UNITED STATES PATENT AND TRADEMARK OFFICE

Fax Cover Sheet

To: Douglas Hamilton c/o Sara McPeak	From: Evan Pert
Application/Control Number: 09/434,736	Art Unit: 2829
Fax No.: 303-571-4321	Phone No.: 703-306-5689
Voice No.: 415-576-0200	Return Fax No.: 703-308-7722
Re: Reissue 09/434,736 and related cases/patent.	CC:

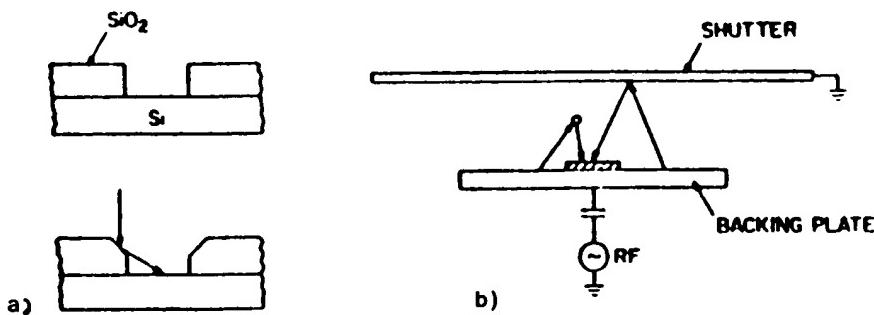
Please see the attached Fig. 3-16(a) textbook excerpt showing an inherent shape of contact holes formed by "anisotropic etching." One of ordinary skill in the art might reasonably ask: How does the inherent and consequential contact hole shape depicted in Fig. 3-16(a) differ from applicant's specially claimed contact hole shape as depicted in applicant's Figs. 2A and 2B ?

At first glance, the inherent shape depicted in the textbook and the intentional shape of the claims appear to be the same on paper by comparison to applicant's drawings. Yet, the examiner believes the record is fairly clear that the shape of applicant's claimed contact holes is an intentional result of a combination of anisotropic and isotropic etching, which would be a different shape than the slightly funnel-shaped, but not-to-scale, contact hole depicted in the attached Fig. 3-16(a). Unfortunately, confusion in scope of applicant's contact hole shape could theoretically arise because applicant's disclosure fails to define any dimensions or procedures for the special funnel-shaped contact hole shape claimed.
